**MUNICIPAL PLANNING COMMISSION
WORK SESSION AGENDA
August 12, 2026, 12:00 pm
Red Bank Court Room
3117 Dayton Boulevard**

Request: Design Review for 3415 and 3423 Dayton Boulevard

DESIGN REVIEW STANDARDS CHECKLIST: 3415 Dayton Boulevard (2026-08-10)

PROPOSED SITE PLAN

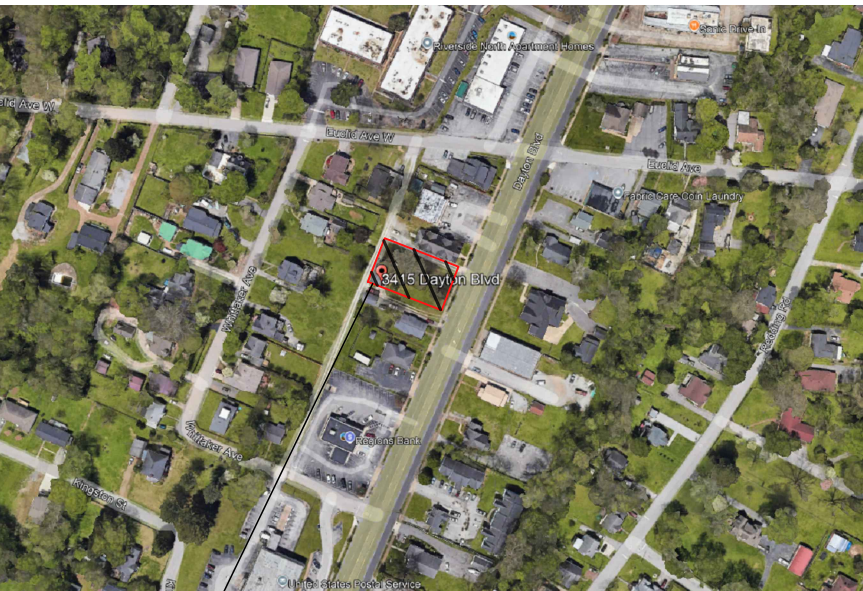
- New buildings must be setback zero (0) feet from the back of the sidewalk, unless a Storefront area with a maximum width of eight (8) feet is provided between the Sidewalk and the Building Zone.

- o ***Building is setback 15' from the sidewalk but does not provide an 8' storefront area.***
- Retail Buildings: façades facing the public right-of-way shall have at least thirty percent (30%) of the façade area comprised of clear vision glass at the ground level

Element	Exceptions and Notes	Design Standard	Description	Y/N
Setback and Orientation	Exceptions to setback requirements in the Building Zone can be made under the following circumstances: a. Exceptions due to steep slopes or other challenging physical site characteristics b. A specific design due to the style or development type approved by the Planning Commission or City Manager that meets the intent, objectives and	New buildings must be setback minimum of seven (7) feet and a maximum of twenty-five (25) feet from the public right-of-way of any street.	15' front setback	yes
		New buildings must be setback zero (0) feet from the back of the sidewalk , unless a Storefront area with a maximum width of eight (8) feet is provided between the Sidewalk and the Building Zone.	15' setback; no proposed storefront area but building exceeds 8' width permitted between sidewalk and building	no

ELEVATION

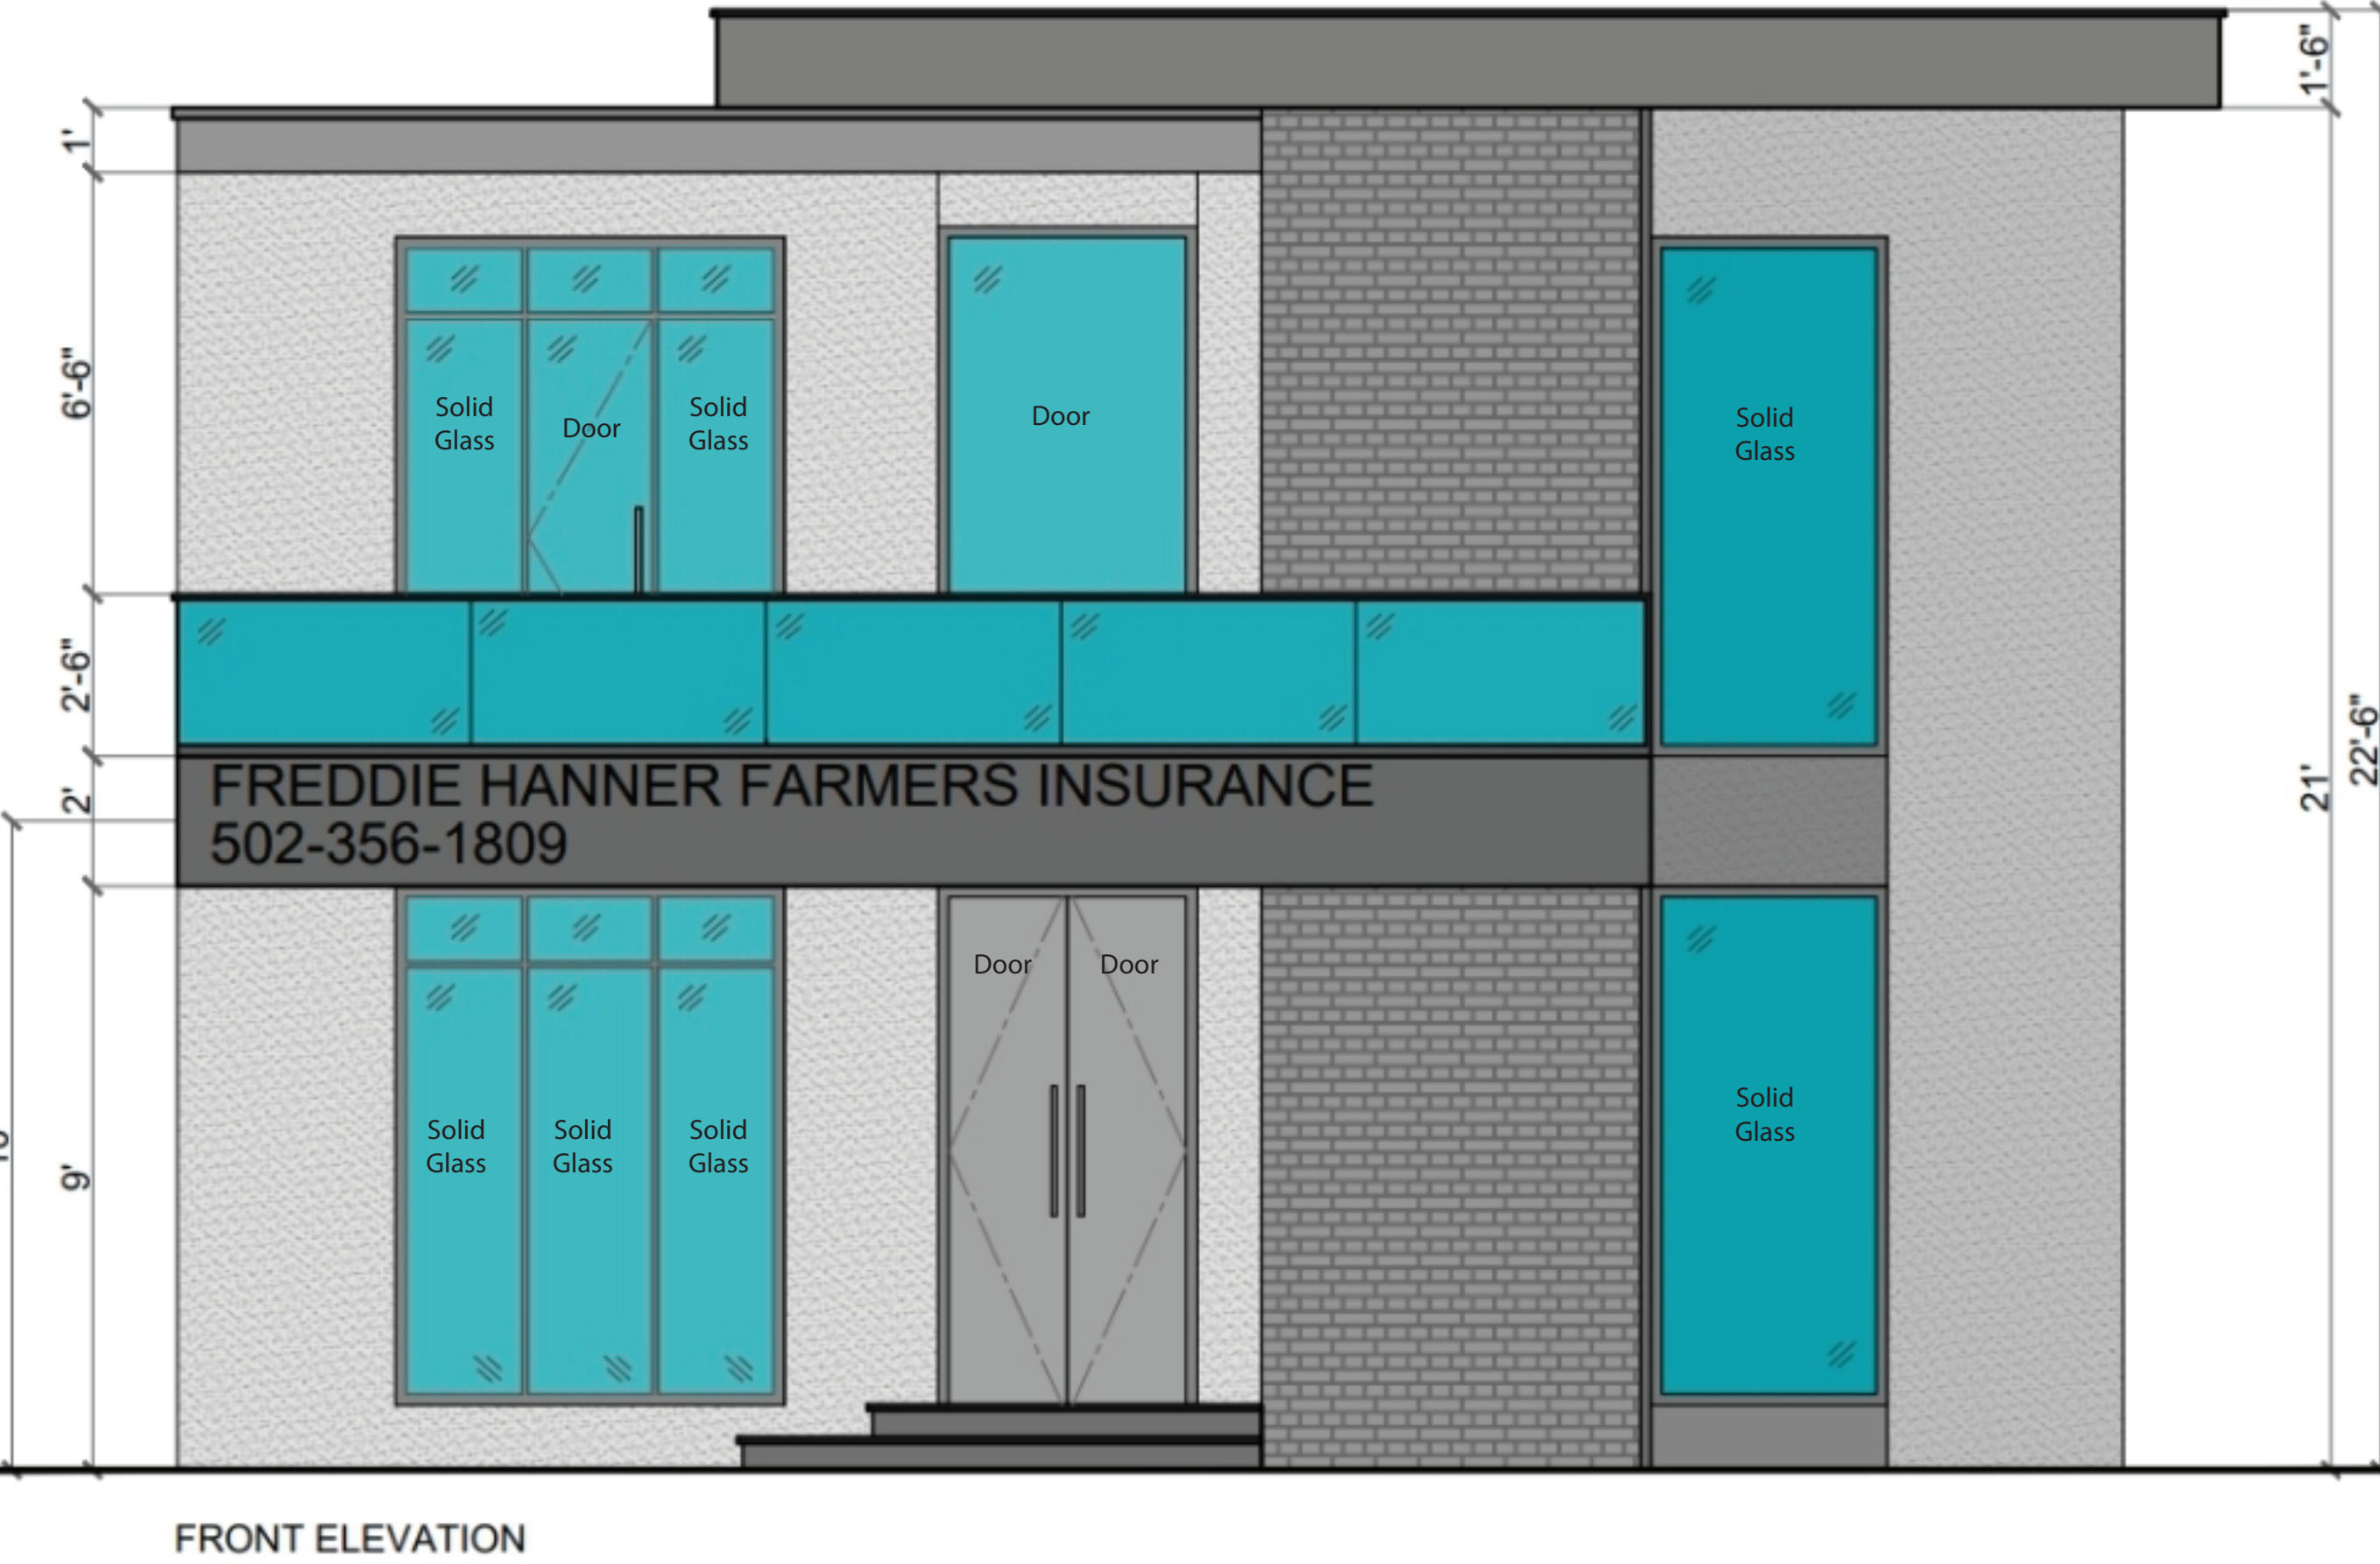
- o ***Clear vision glass percentage not shown***
- Mechanical equipment located on roof tops shall be screened from the public right-of-way.
 - o ***No mechanical equipment shown***

Element	Exceptions and Notes	Design Standard	Description	Y/N
		No single approved material (excluding glass) shall exceed seventy (70%) percent of the exterior building wall(s) that is visible from a public right- of-way and shall be comprised from the following alternative materials: factory-primed fiber-cement lap siding, glass, brick, stone, hard coat stucco, pre-cast concrete, architectural metal panels, and faux stone, and other materials as approved.	Sheet A-06 lists brick veneer, faux stone, primed fiber-cement as the exterior finish	no
		Does not contain prohibited materials visible from public right-of-way: flat metal or corrugated tin or zinc coated siding, vinyl (or similar) siding, and unpainted/untreated concrete block. Commercial zones only.	No prohibited materials proposed	yes
Façade Transparency	Specific alternative designs may be approved by the Planning Commission or City Manager. Tinted or reflecting glass is discouraged.	Retail Buildings: façades facing the public right-of-way shall have at least thirty percent (30%) of the façade area comprised of clear vision glass at the ground level	Calculations shown state glass windows doors and balcony railings are 35.7% of the facade	yes

Element	Exceptions and Notes	Design Standard	Description	Y/N
	Horizontal articulations in buildings, such as building step-backs or rooftop balconies, are encouraged.	the use of articulation. Articulation may include: a. offsets, b. recesses, c. staggered walls, d. stepped walls, e. pitched or stepped rooflines, f. overhangs, or g. other elements of the building's mass.		
		Building height shall be compatible with the height of neighboring buildings that are built close to the street.	Single story to the south, two-story to the north	Yes
Roof Expression	Multi-family developments are exempt from Roof Expression standards.	Buildings should include extended parapets, projecting cornices, or similar features that define the top of the building and create a prominent edge when viewed against the sky.	Extended parapet shown	Yes
	Residential roof styles, including hipped and gabled roofs are discouraged. Active roofs with gardens and outdoor seating are permitted. Parapets should be extended and embellished.	Mechanical equipment located on roof tops shall be screened from the public right-of-way.	No mechanical equipment shown	No

LIGHTING LAYOUT

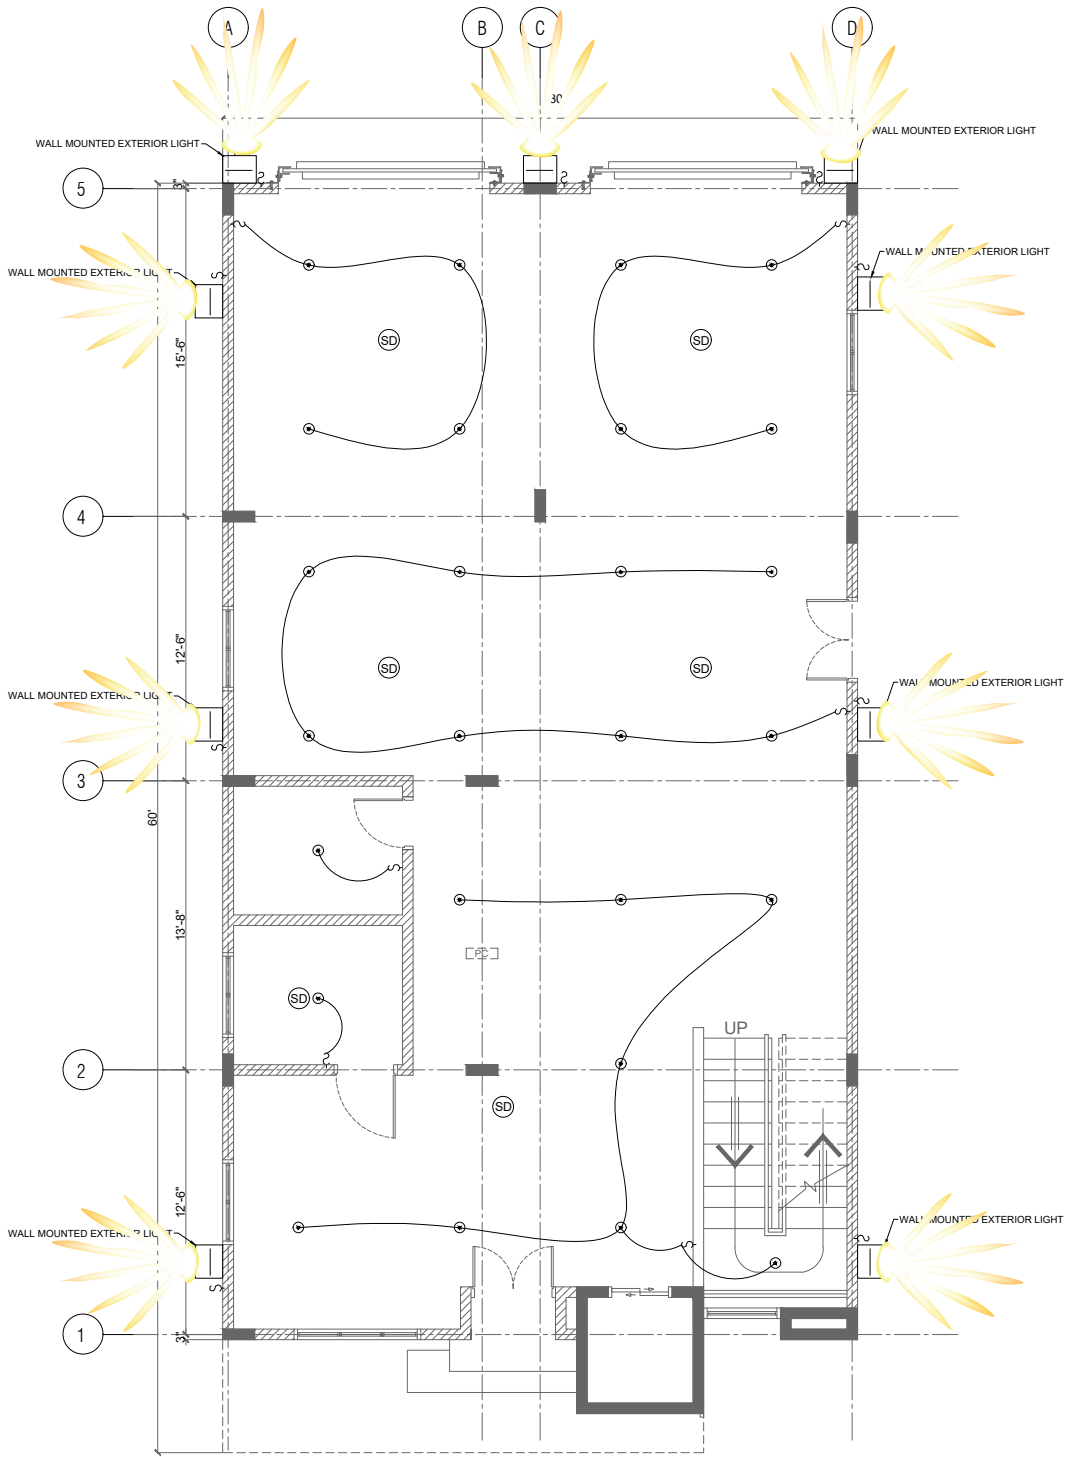
- Parking lot lighting shall be appropriate to create adequate visibility at night and evenly distributed to increase security. Parking lots must have a minimum illumination of 0.8 foot-candles at the ground level.

- o ***Ground level illumination not shown, but product cut sheet implies that minimum illumination is met.***
- Design standards and requirements that relate to trees, vegetation, terrain and waterways were not met.

Element	Exceptions	Design Standard	Description	Y/N
Lighting	Applicable only to new development. Existing lighting that is fully functional may be utilized.	Street lighting will be installed in front of all new development on Dayton Boulevard to the maximum extent practicable.	Existing EPB lamp posts	n/a
		Streetlights along or within the Pedestrian Zone shall be of the same design, type, spacing and mounting height and shall consist of lamp top post lighting matching the existing lamps.	Existing EPB lamp posts	n/a
		New lighting in the Pedestrian Zone shall be aligned with the street trees and parallel to the edge of the public right-of-way.	Existing EPB lamp posts	n/a
		Exterior lighting shall be equipped with full cut- offs to direct light downward and to minimize glare, shadows, night sky pollution, and excessive light levels.	A-09 shows nine(9) wall mounted exterior lights; applicant included a screen shot of a 200 watt, 28,000 lumen LED light with no cutoff shown	No

Element	Exceptions and Notes	Design Standard	Description	Y/N
		Parking lot landscaping should incorporate best management practices (BMPs) for storm water and other green infrastructure into the design are encouraged to reduce storm water runoff and pollution. Applicants should refer to the Hamilton County Water Quality Manual for guidance on appropriate storm water BMPs for their site.		n/a
Parking Lot Lighting	Existing lighting structures, fixtures and bulbs are exempt from these standards.	All New lighting fixtures and bulbs shall be LED, shielded if necessary, equipped with refractors, or placed indirectly to prevent stray upward light or direct light causing glare.	A-08 shows nine(9) wall mounted exterior lights; applicant included a scan of a product sheet for a light that meets the standards	No
	Special interest and accent lightings are encouraged to be integrated with landscaping and streetscape features.	New pedestrian-scale lighting should be provided on the walkways, parking lots and open spaces consistent with the character of the development.	A-08 shows nine(9) wall mounted exterior lights; applicant included a scan of a product sheet for a light that meets the standards	No
